# AXOD/AXODE (AX4S) UPDATE HANDBOOK

# INTRODUCTION

This updated version of the AXOD "Update Handbook" will also cover the changes that occurred in the 1991 model year, when electronic controls were adapted to the AXOD transaxle, making it an AXODE, and now called an AX4S transaxle. We have included the changes on the AX4S transaxle up through and including model year 2002.

Figure 60

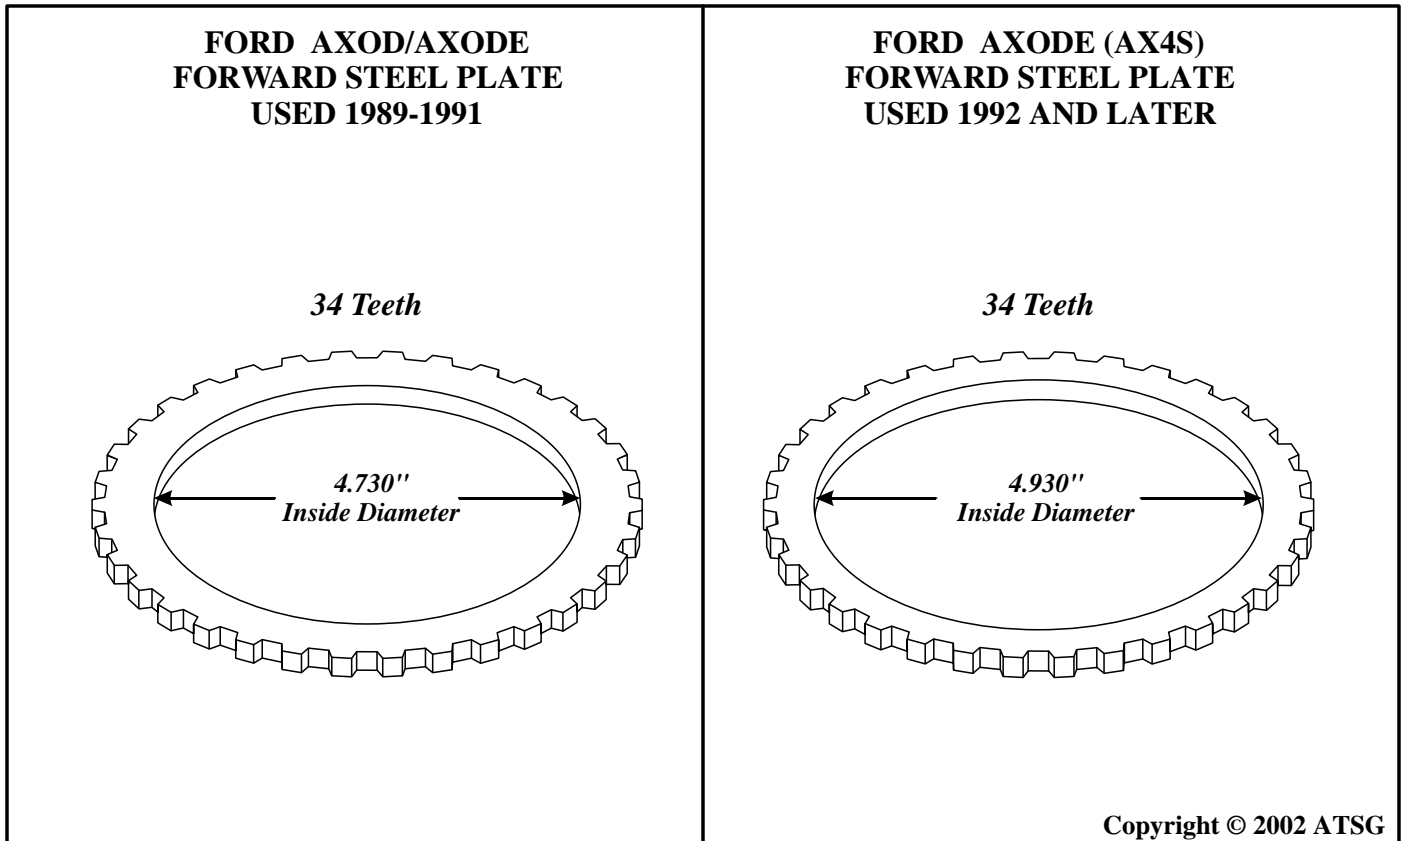
- (4) FORWARD CLUTCH PRESSURE PLATE - Has an increased inside diameter to 4.930" from the previous 4.730", to accommodate the increased diameter of the sprag outer race, as shown in Figure 60.

Figure 63

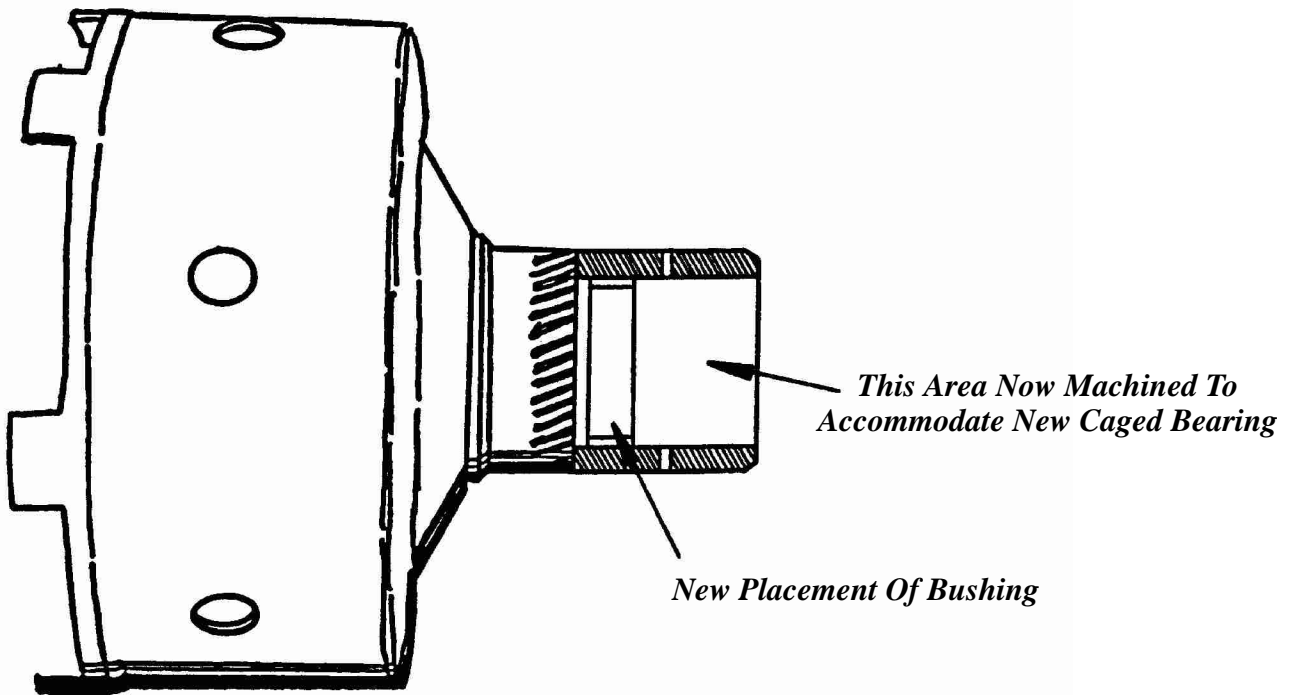
- (1) INPUT PLANETARY CARRIER - New caged needle Bearing added to the shaft on the Input Planetary Carrier, as shown in Figure 62.
- (2) SUN GEAR AND SHELL ASSEMBLY - Single bushing is now located in front of the lube holes in the sun gear, and the area behind is now machined to accommodate the new caged needle bearing, as shown in Figure 63.

The new design parts listed above will back service all previous models, *but must be used together as a set.*

Figure 64

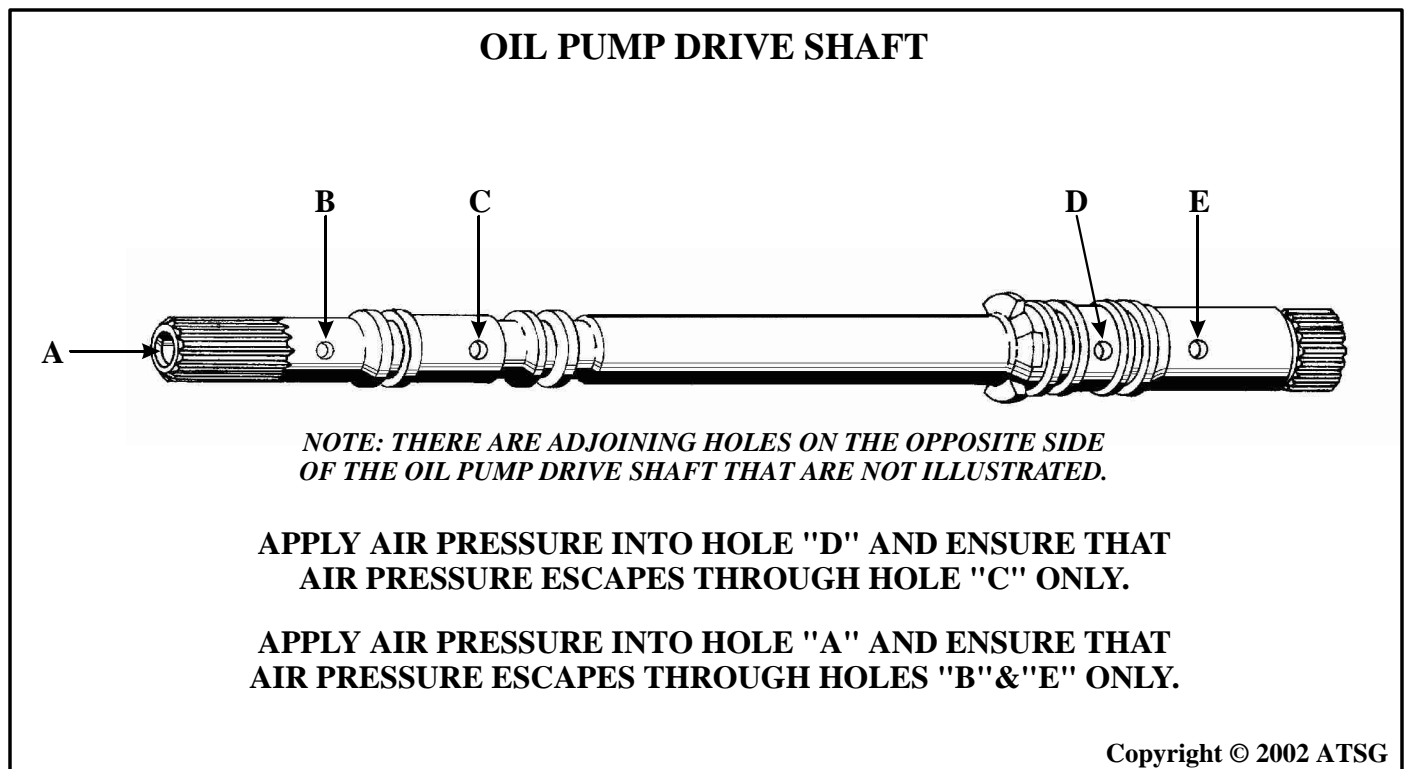
**CORRECTION:** Refer to Figure 64 to *check* the Oil Pump Drive Shaft, and clean or replace as necessary.

Figure 66

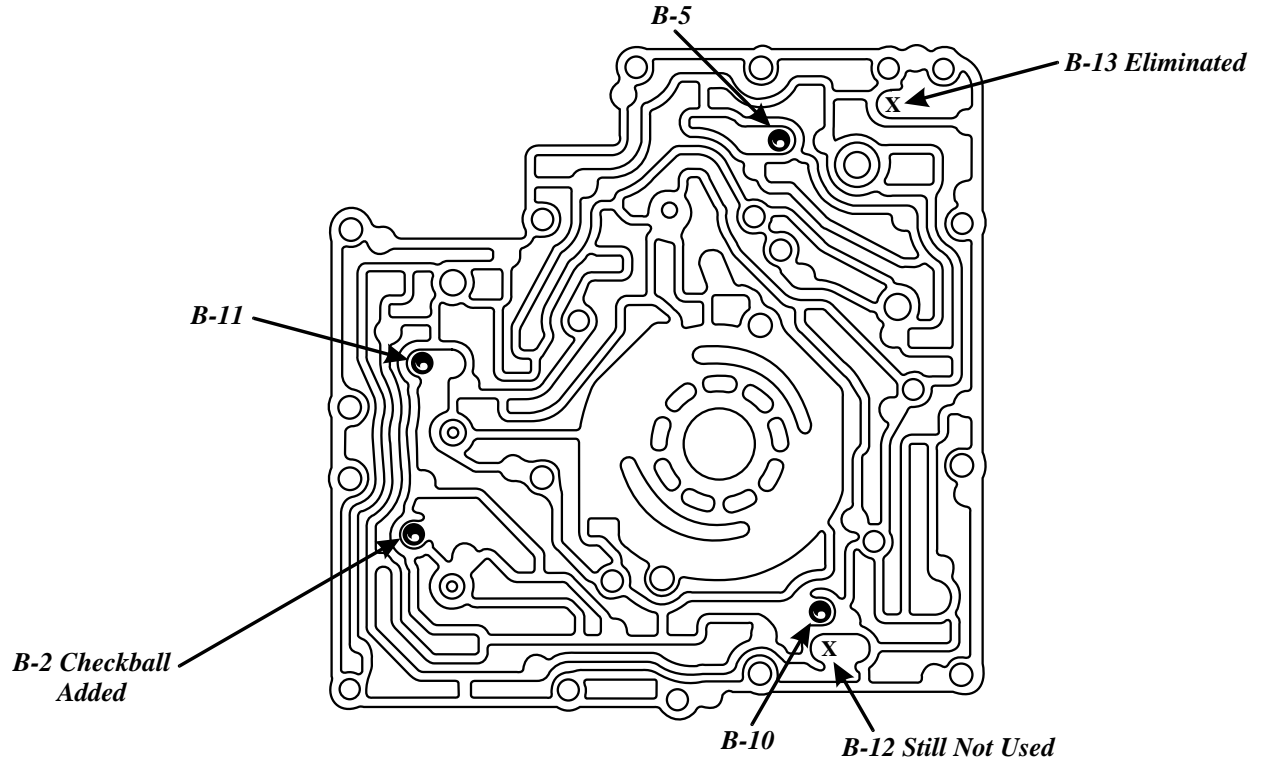
*1992-1998 Only - Uses 4 checkballs but in different locations, as shown in Figure 66. B-13 checkball was eliminated and B-2 checkball was added.*

*1999-2002 Only - Uses 3 checkballs in the locations shown in Figure 66. B-5 checkball was eliminated.*

Figure 75

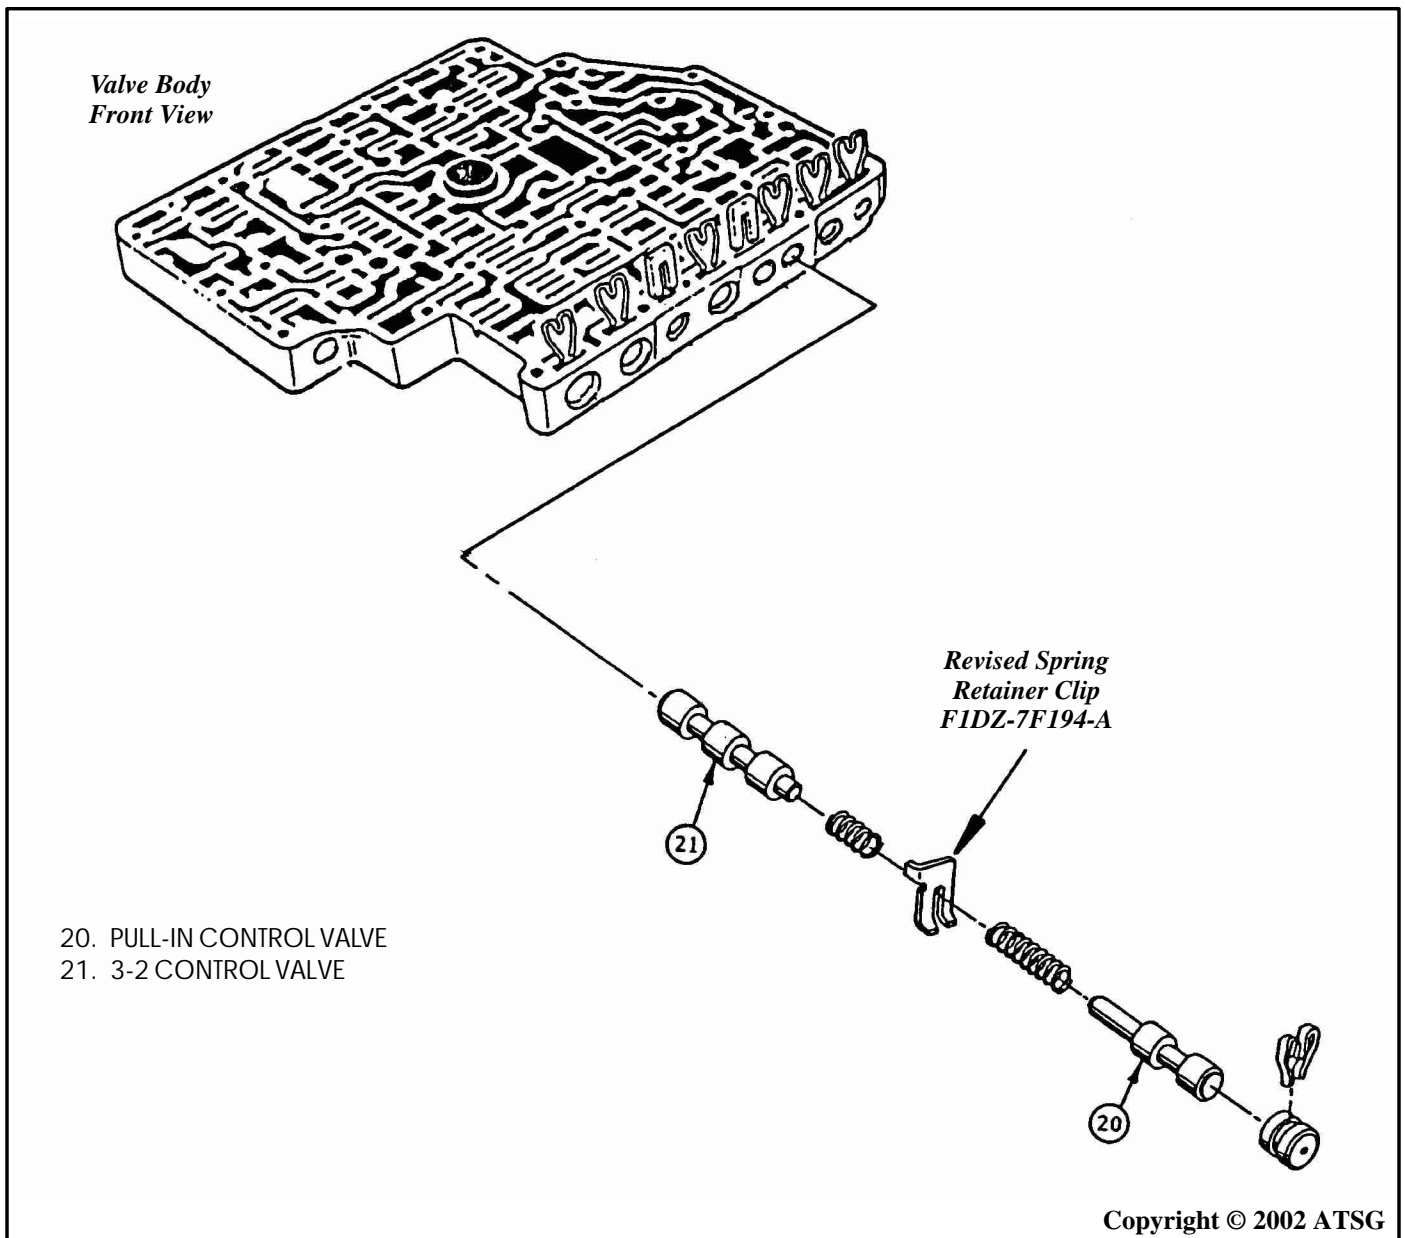
**CAUSE:** The cause may be, a broken spring retainer clip between the pull-in control valve spring and the 3-2 control valve spring, as shown in Figure 75.

**CORRECTION:** Replace the spring retainer clip with OEM part number F1DZ-7F194-A, as shown in Figure 75.

Figure 83

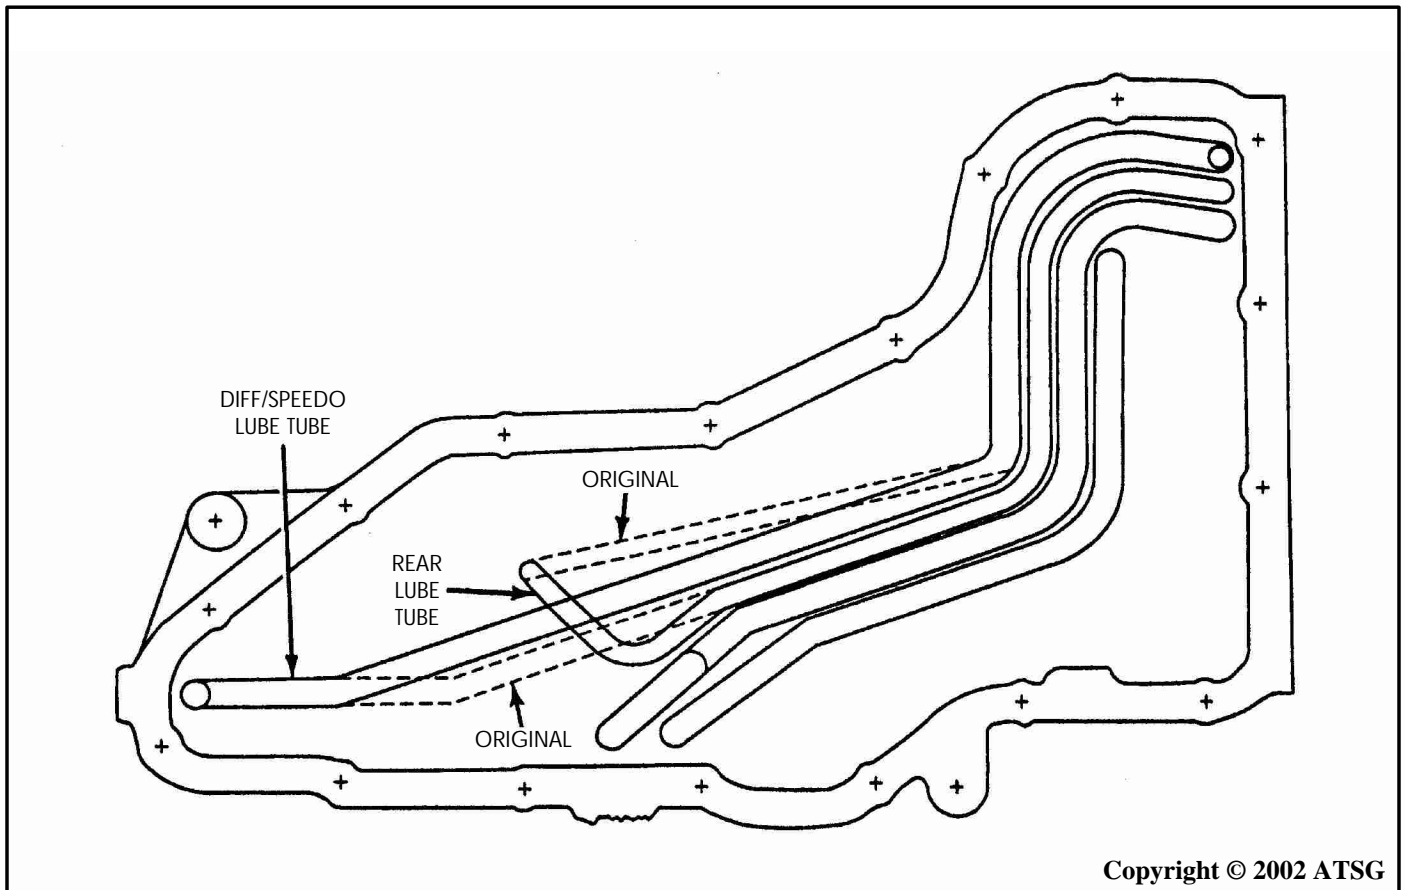
**CAUSE:** The cause may be, a limited volume of lube oil to the front planetary due to hydraulic control system demands.

**CORRECTION:** Install a new design "Cross-over" rear lube tube and a new design Differential/Speedo lube tube, that will increase the volume of lube oil to the front planetary system, as shown in Figure 83. This requires the rear lube tube to "Cross-over" the differential and speedo lube tube, as shown in Figure 83.

Figure 85

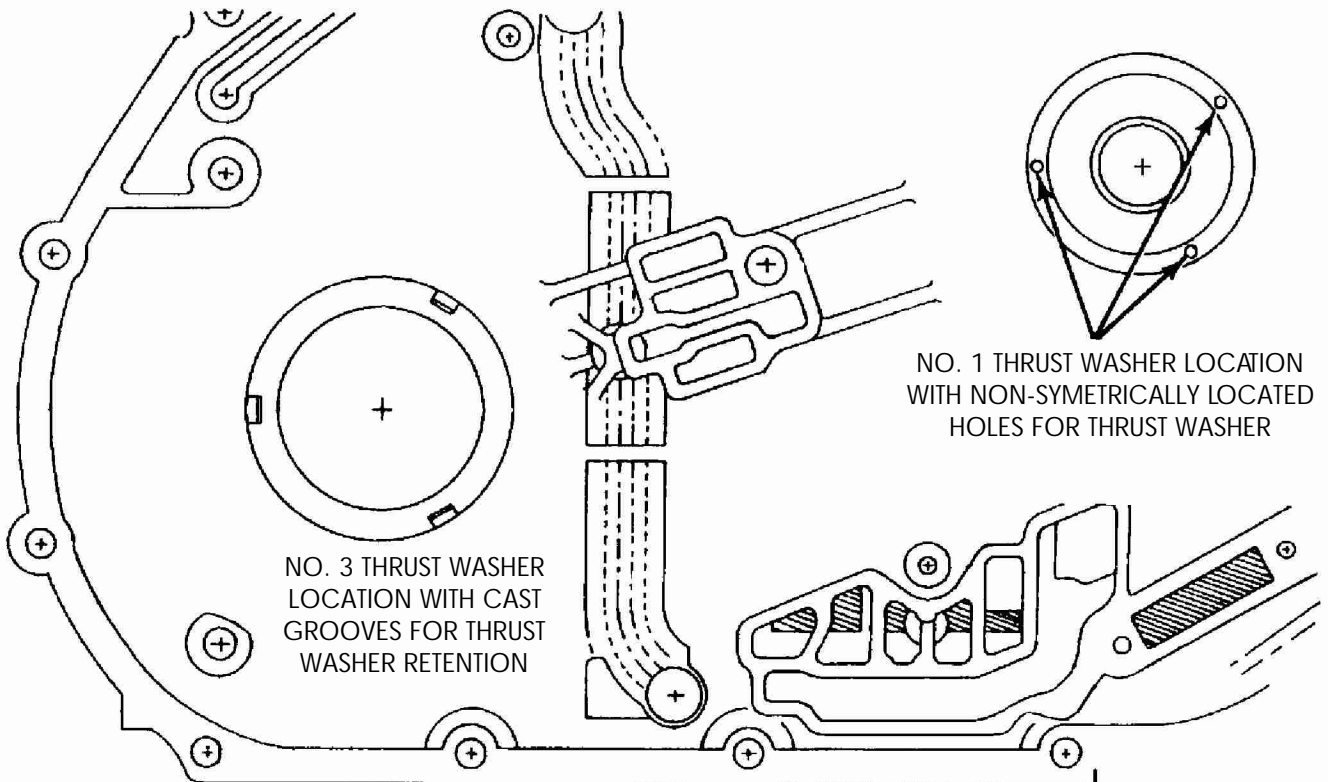
- (3) CHAIN COVER - New design will accept either the previous bronze No. 3 thrust washer with the tangs on outside diameter, or the new design Black plastic No. 3 thrust washer with the 3 symmetrically located tabs, as shown in Figure 86.  
The previous design Chain Cover will accept *only* the bronze No. 3 thrust washer with the tangs on the outside diameter, as shown in Figure 85.  
The new design Chain Cover will accept *only* the new design No. 1 thrust washer with 3 symmetrically located tabs, as shown in Figure 86.  
The previous design Chain Cover will accept *only* the previous design No. 1 thrust washer with 3 non-symmetrically located tabs, as shown in Figure 85.

If replacement of the number 1 and/or the number 3 thrust washer becomes necessary, inspect the chain cover in the thrust washer tab areas to determine the correct thrust washers required. Refer to Figures 85 and 86.

Figure 90

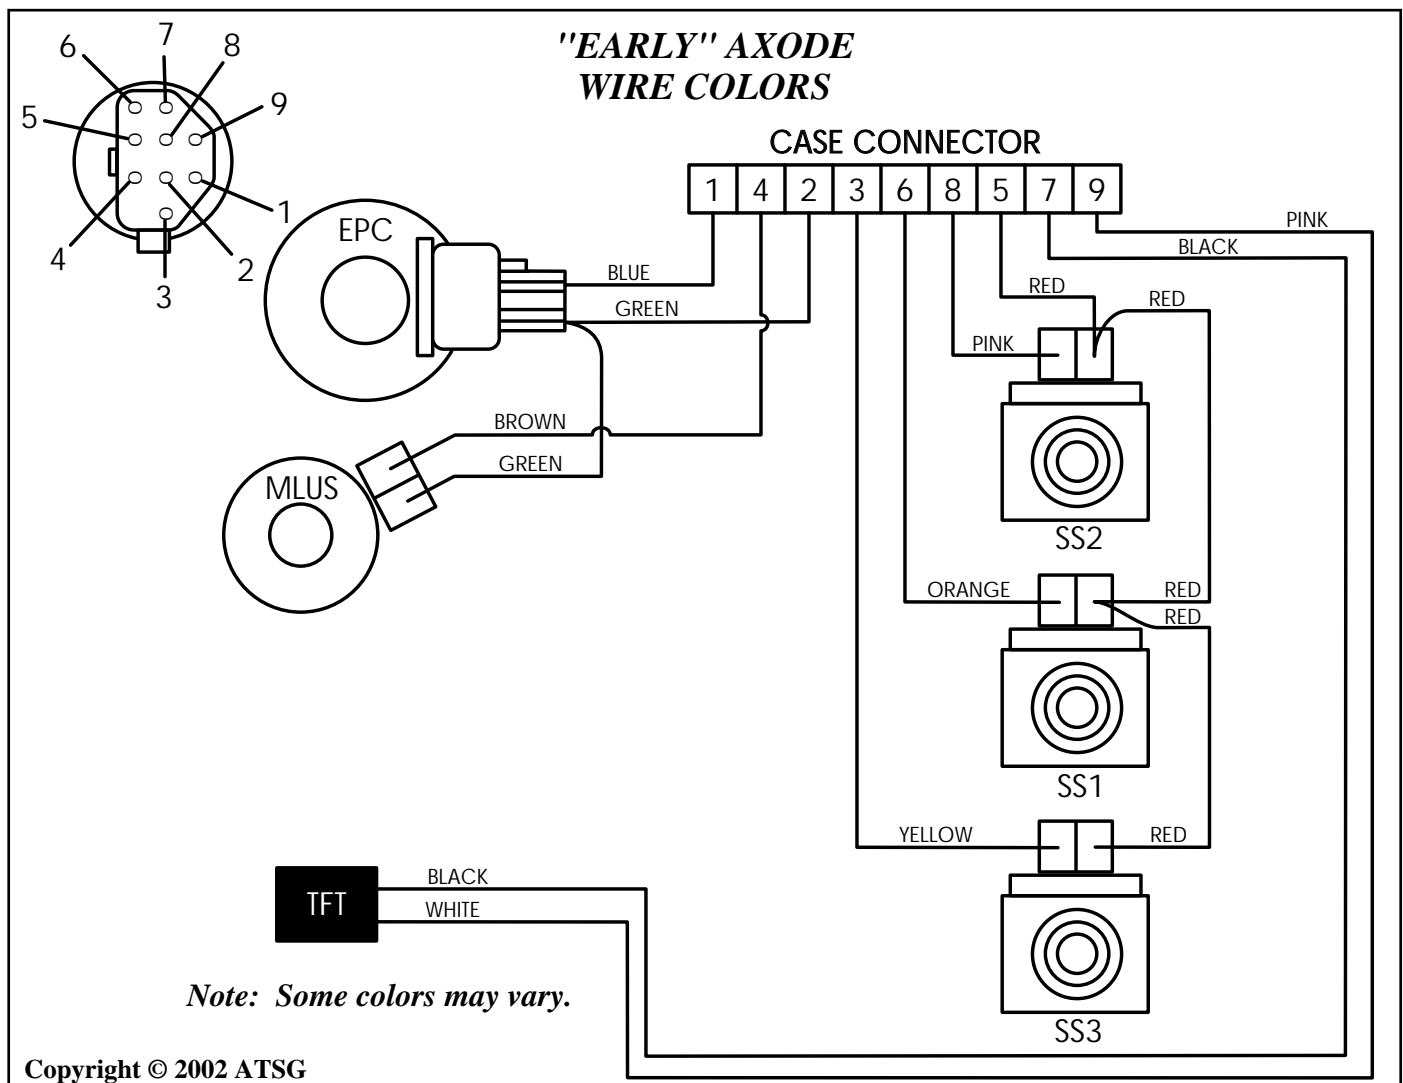
**CORRECTION:** Connect the internal wiring harness connectors to their proper solenoids, *using the wire colors*, as shown in Figure 90 and 91. Proper connection of solenoids can also be verified externally through the case connector using the Ohms chart in Figure 91.
